CROSS SECTIONS

REVISED NDC02	STATE VA.	ROUTE 621	STATE PROJECT 6234-076-266, C-501, RW-201	SHEET NO. X178
------------------	--------------	--------------	--	-------------------

Ramp 1A

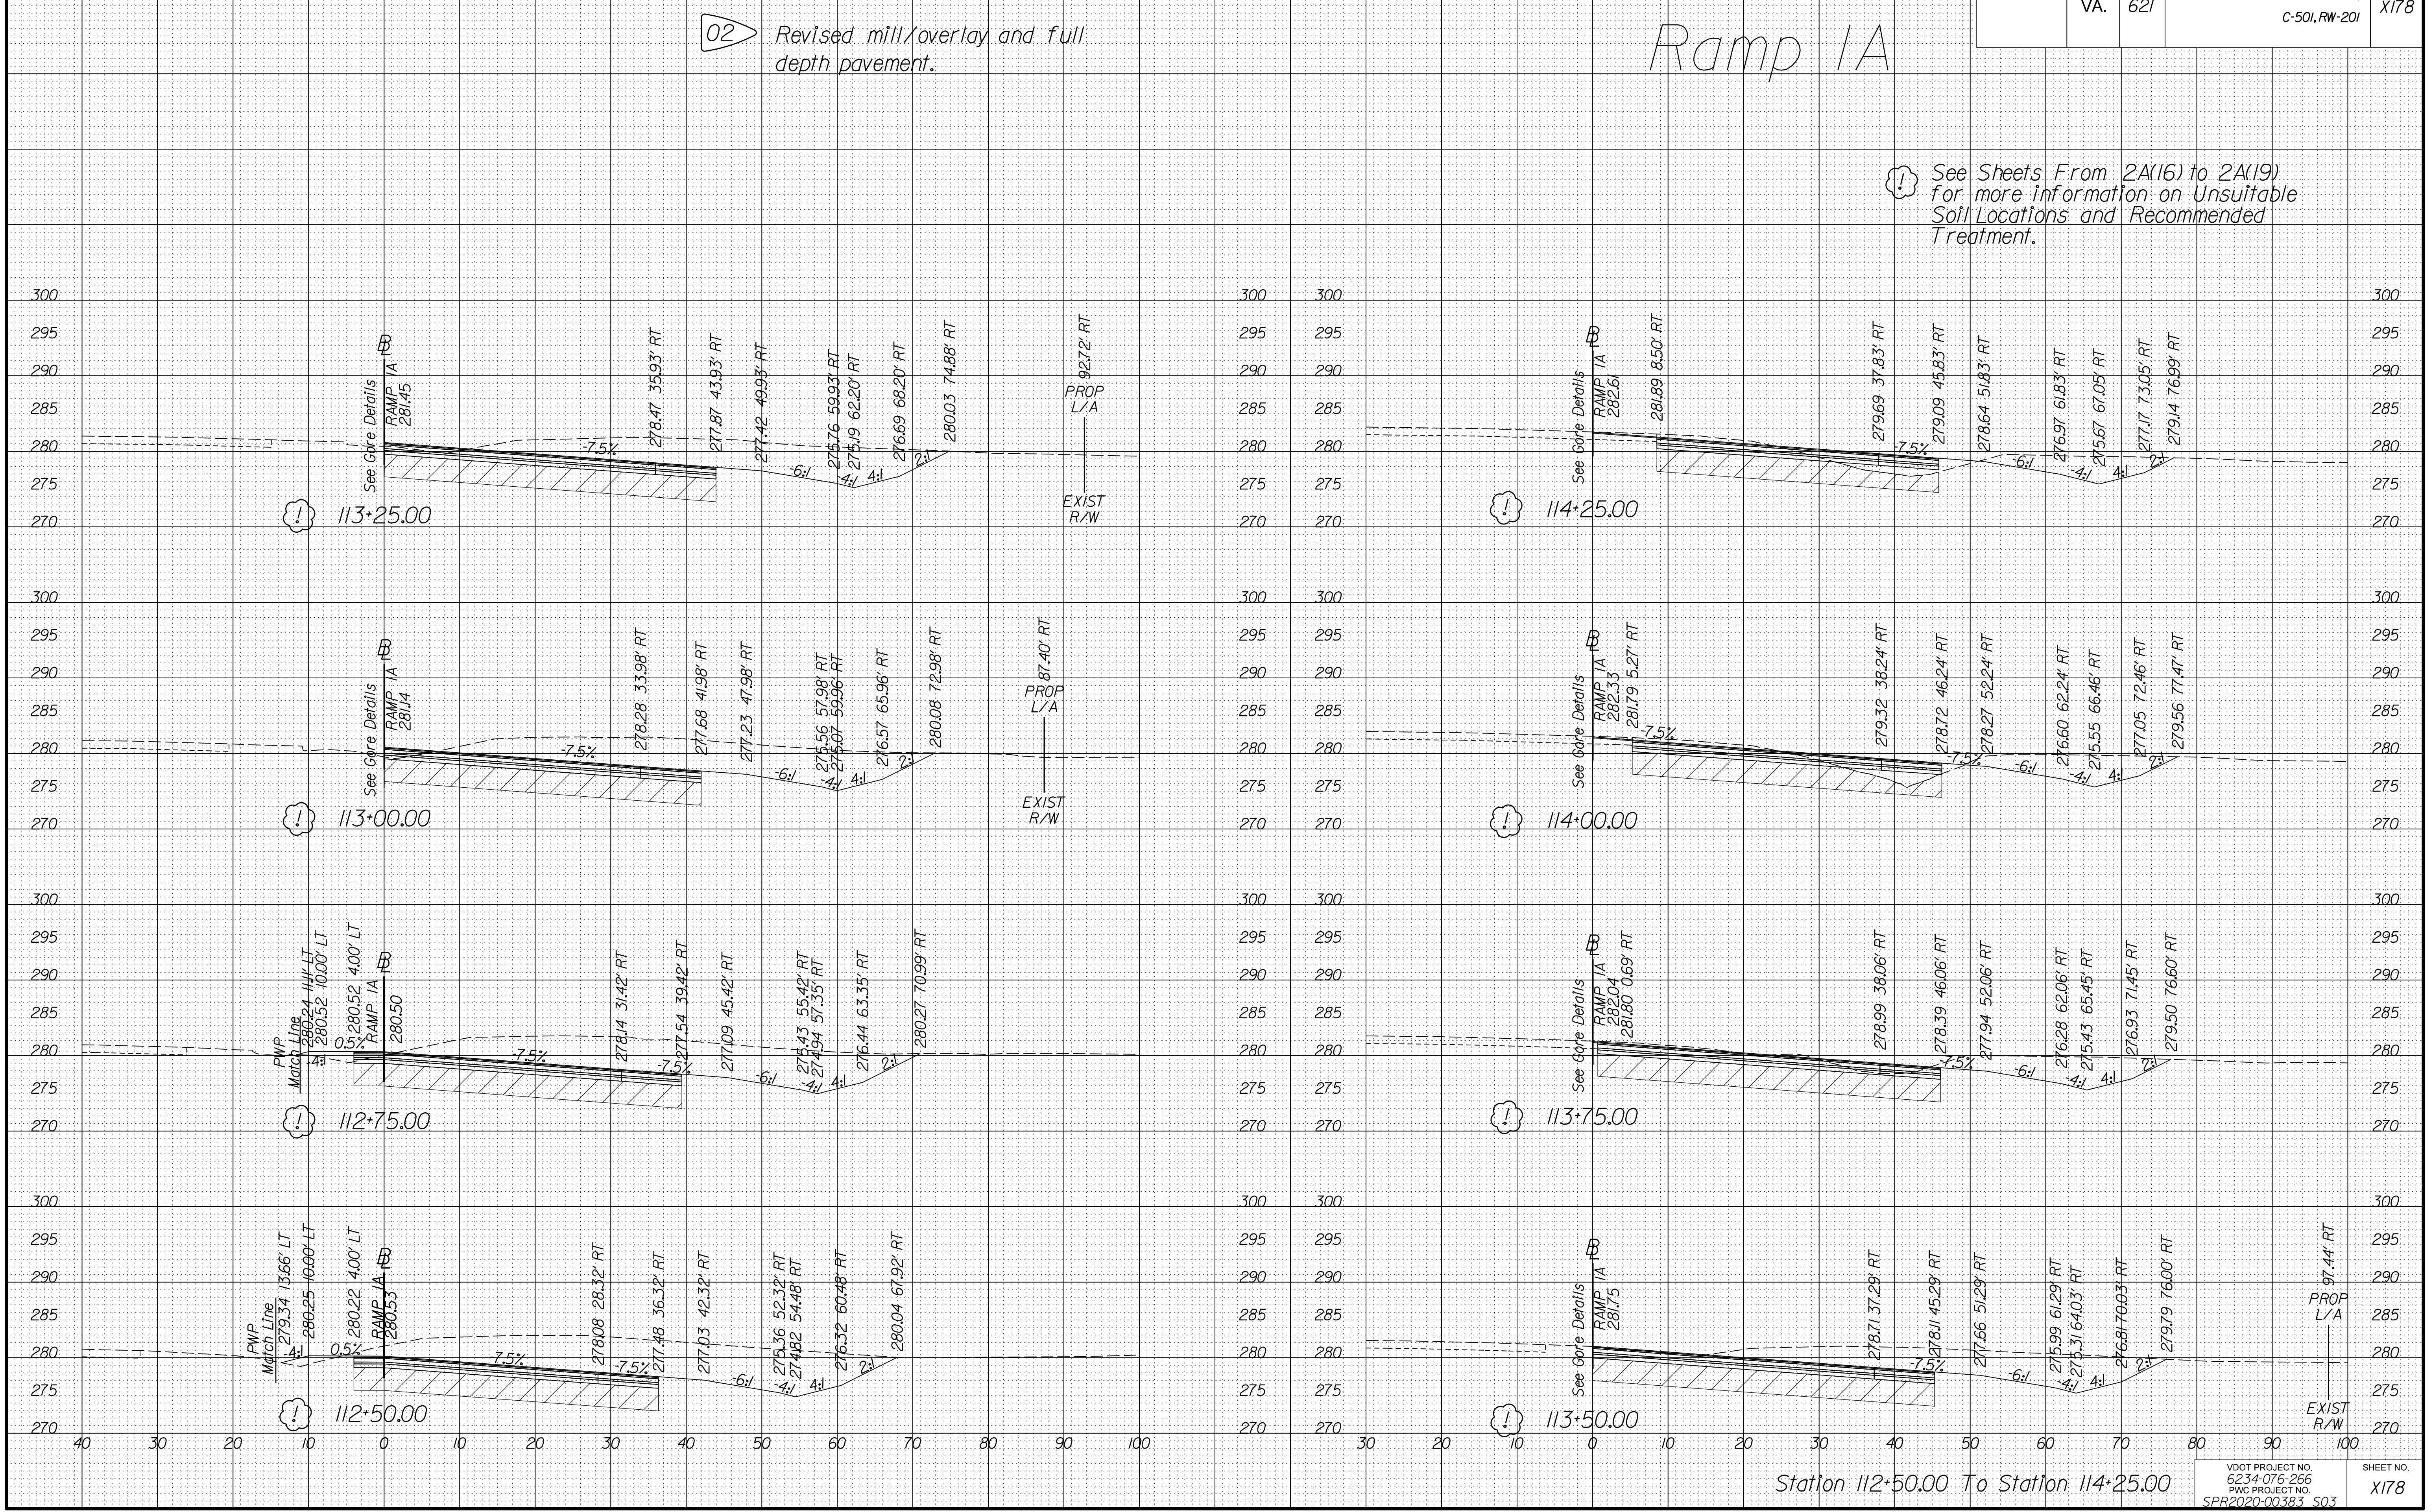
02 Revised mill/overlay and full depth pavement.

REVISED NDC02	STATE VA.	ROUTE 621	STATE PROJECT 6234-076-266, C-501, RW-201	SHEET NO. X180
------------------	--------------	--------------	--	-------------------

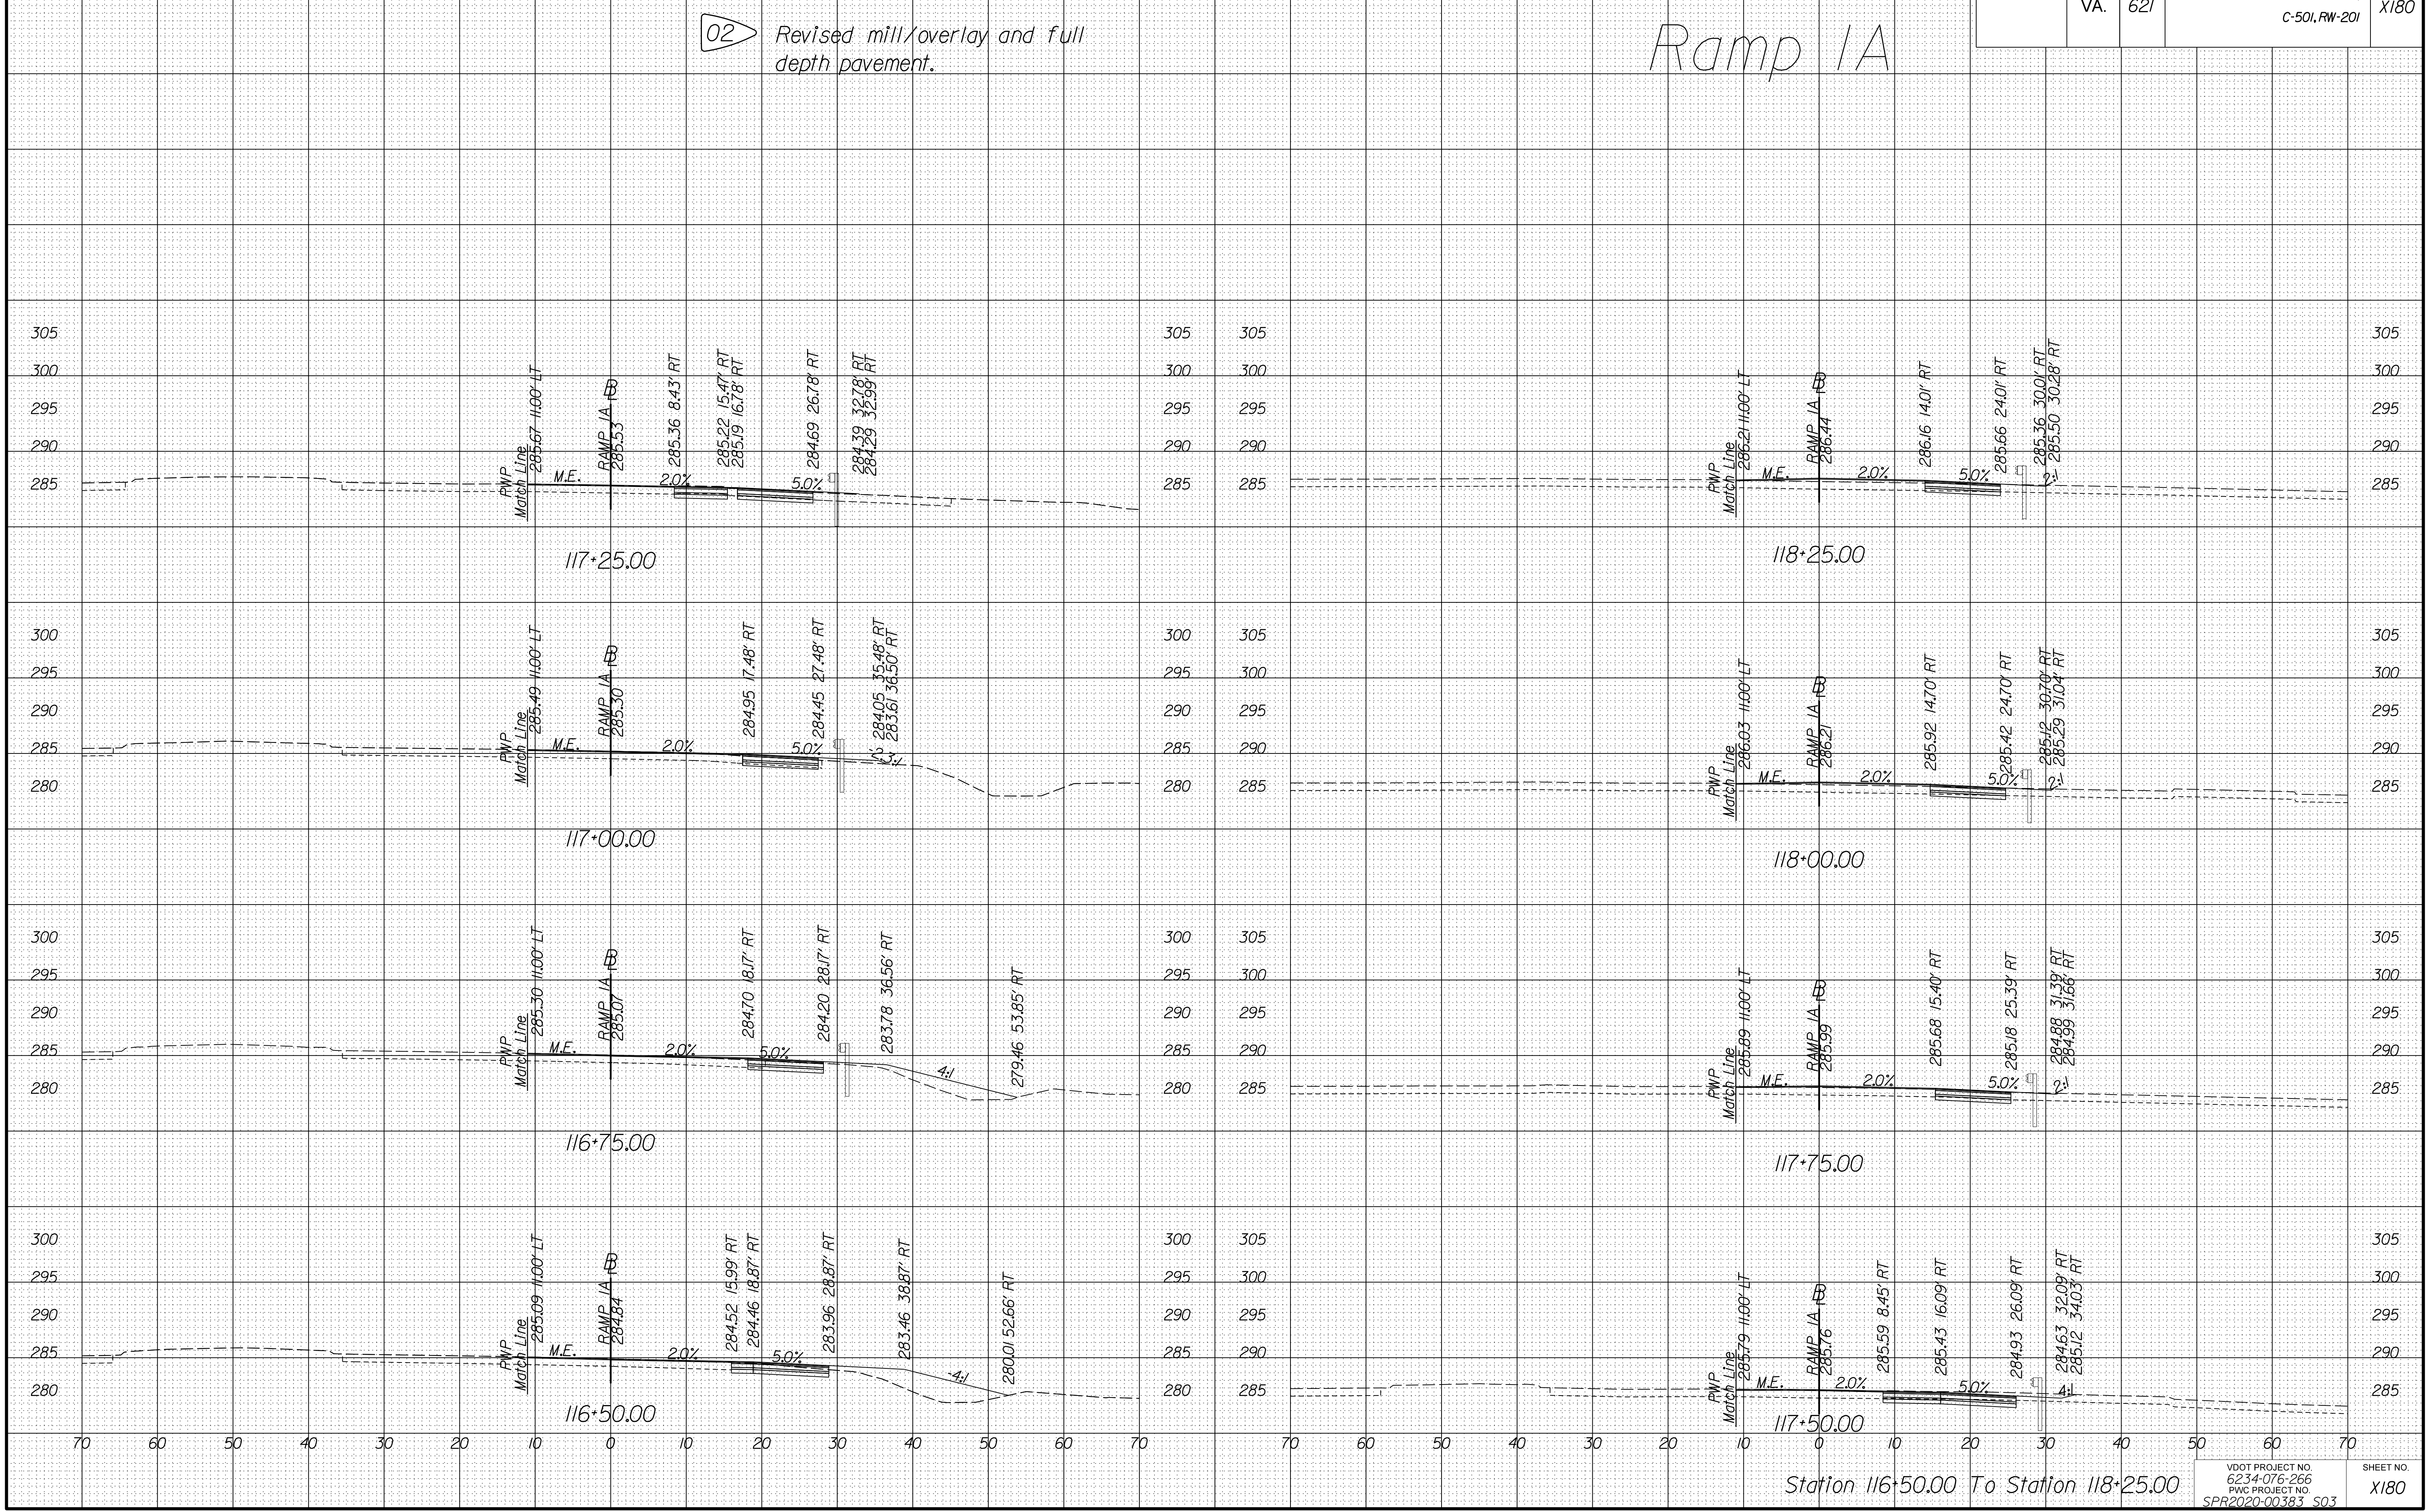
02 Revised mill/overlay and full depth pavement.

REVISED NDC02	STATE VA.	ROUTE 621	STATE PROJECT 6234-076-266, C-501, RW-201	SHEET NO. X182
------------------	--------------	--------------	--	-------------------

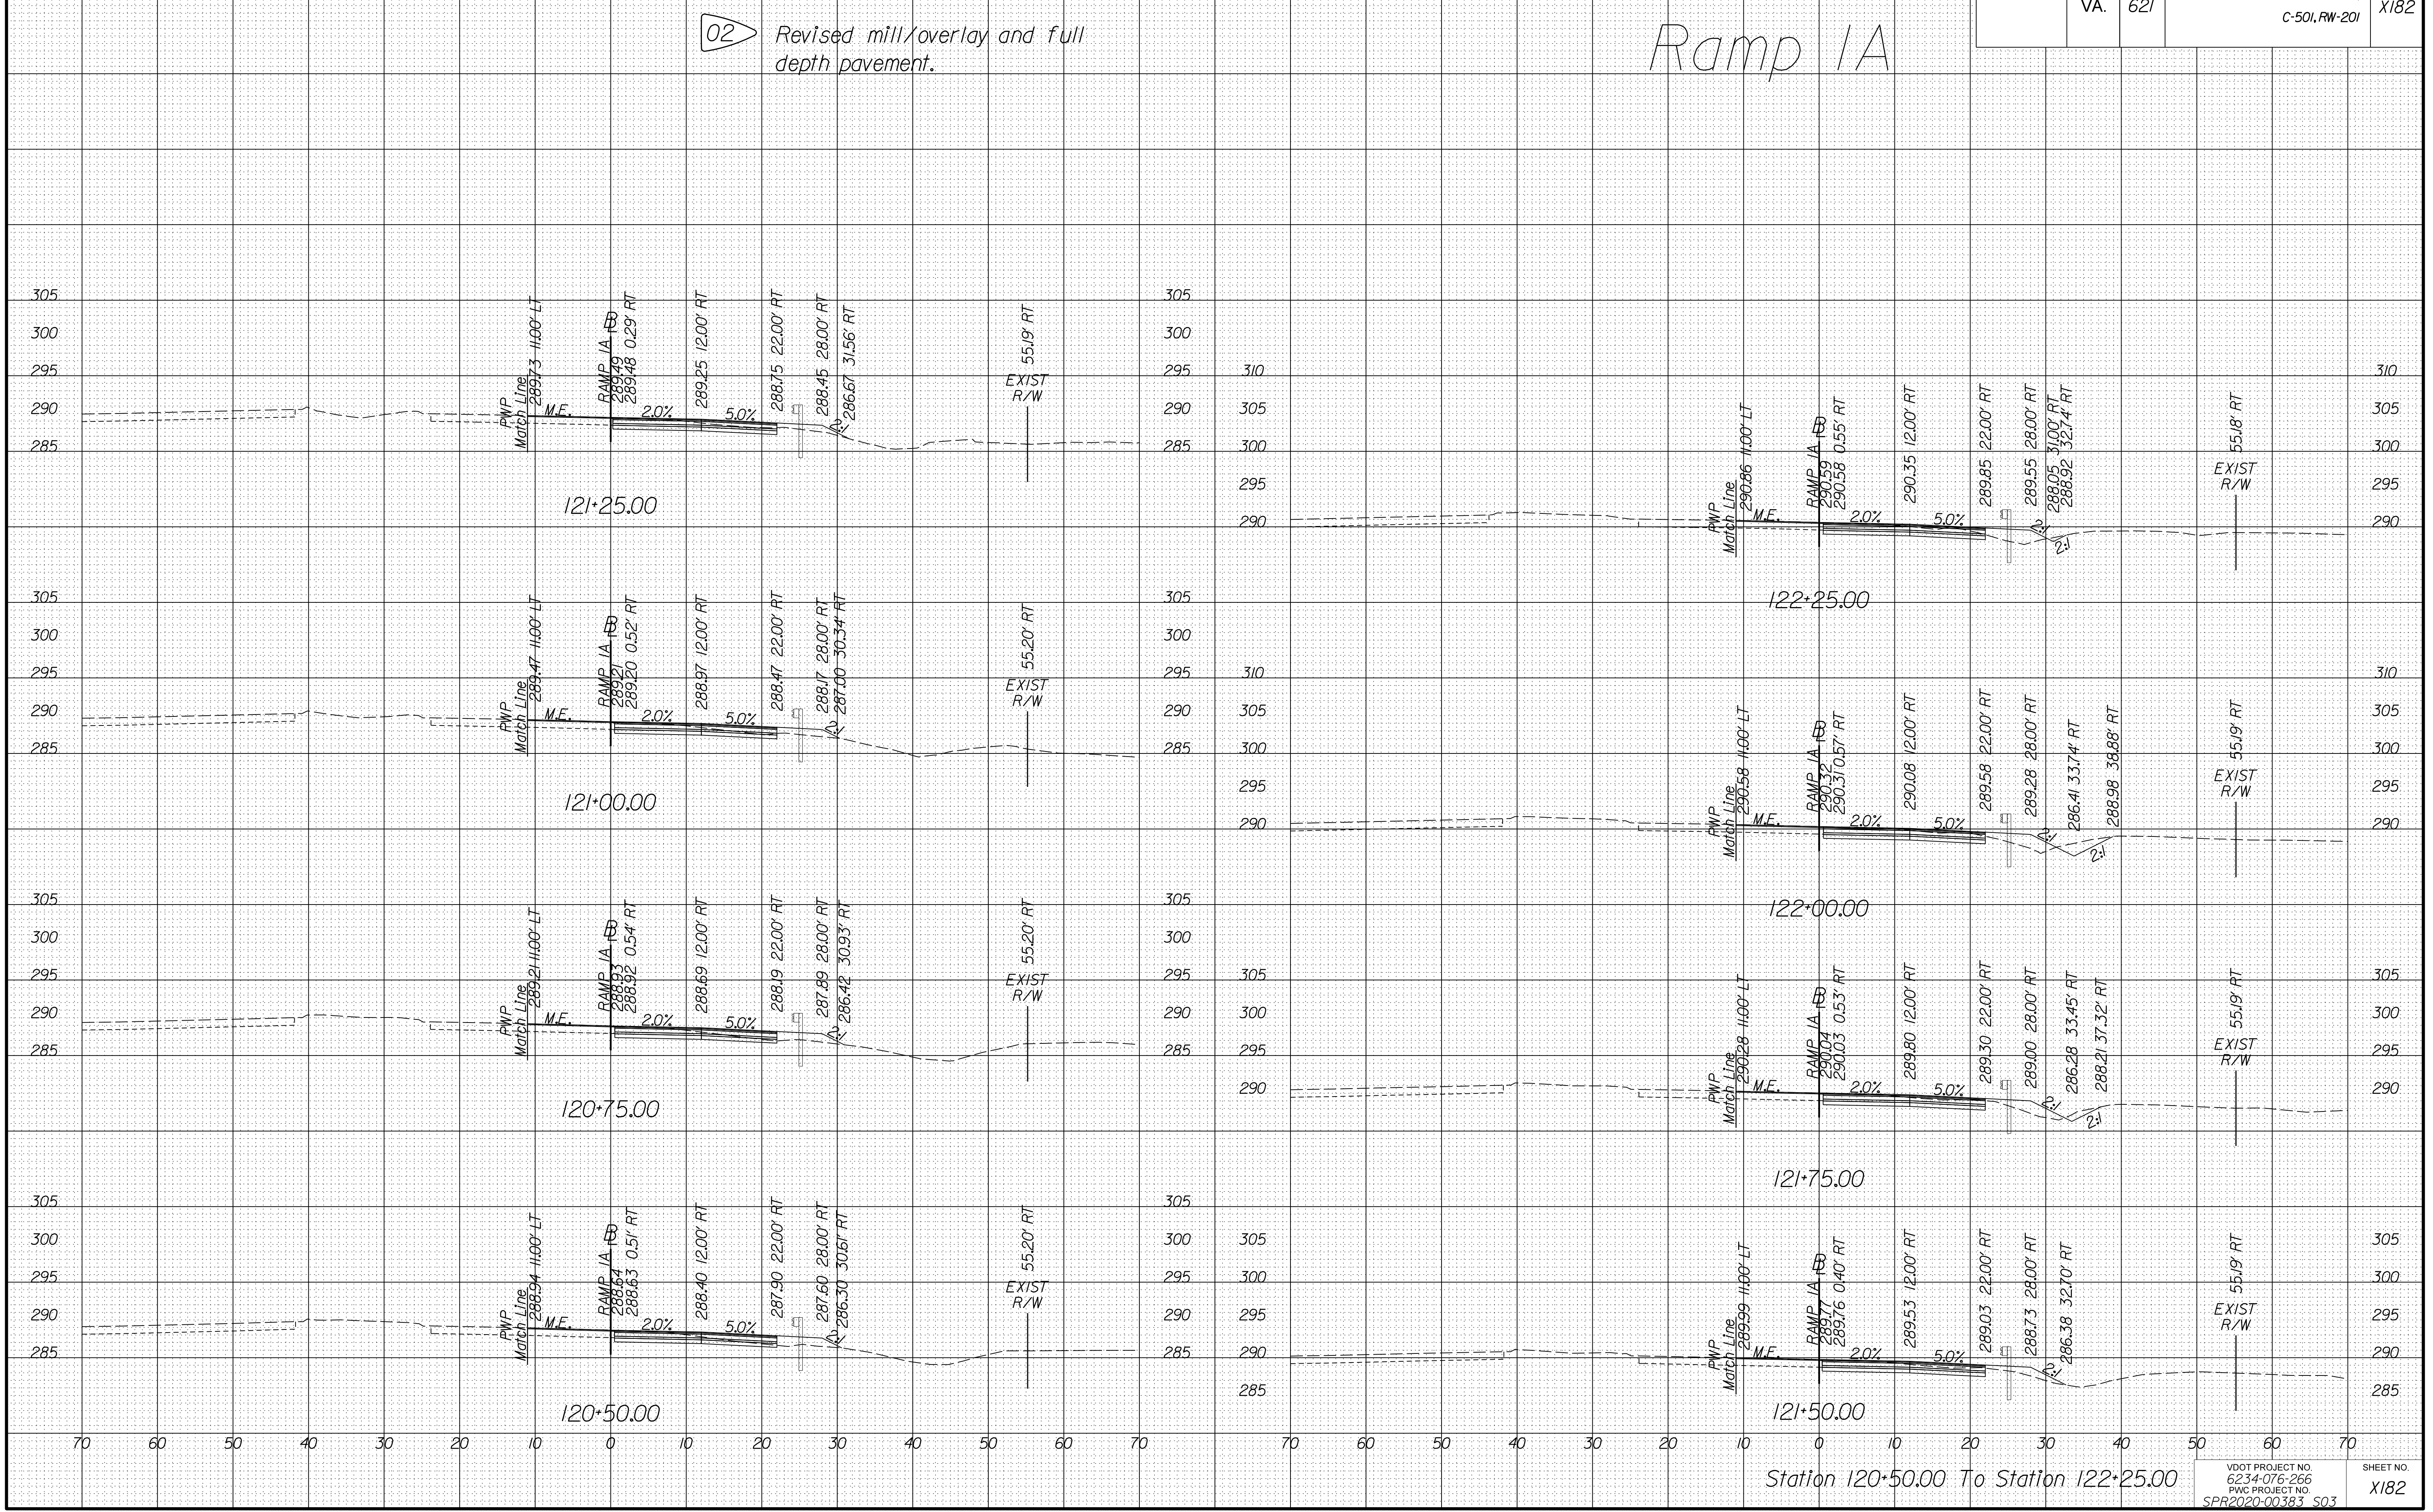
02 Revised mill/overlay and full depth pavement.
